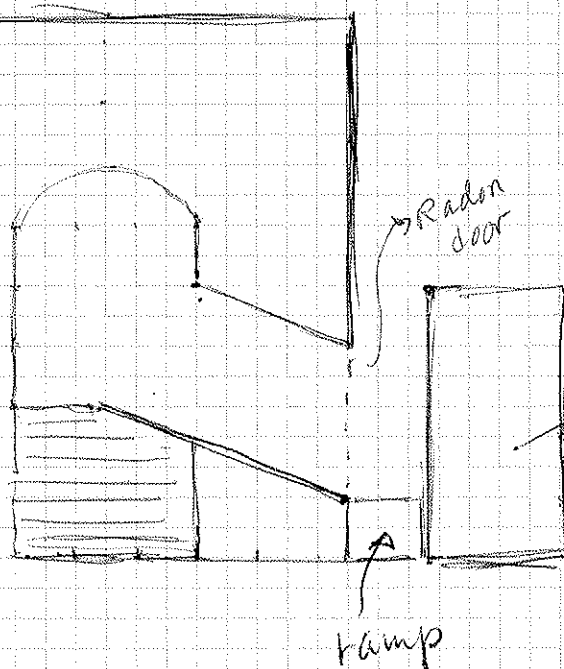
No Internal Ramp.

If floor of lift is shielding, then need hardly any further shielding + doubles as radon door

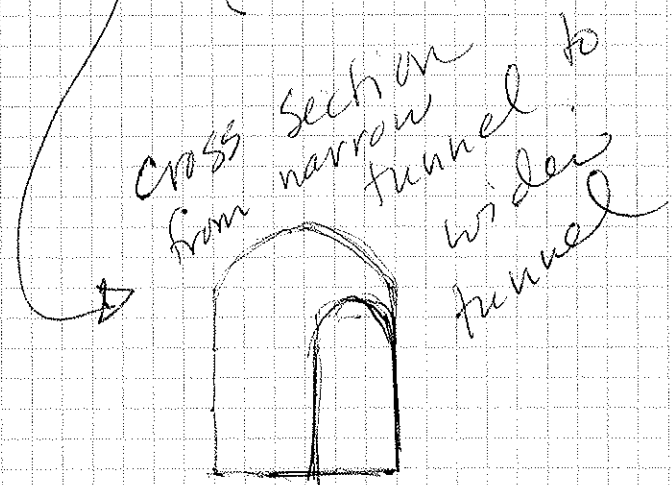
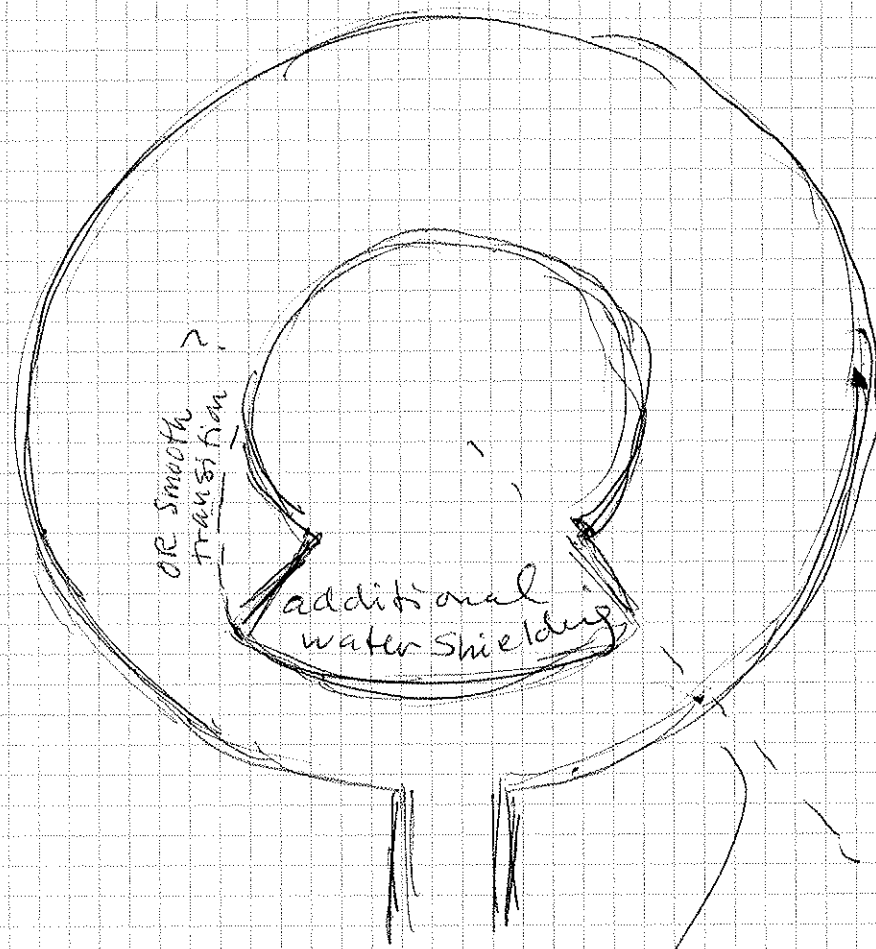
1.5 m down over 4 m run (too steep?)

2.5 m height clearance (too short?)

Can water be used for Shadow Shielding?

Can acrylic tunnels be made this way?

How do they change diameter?
Water pressure on flat surfaces = Bad.
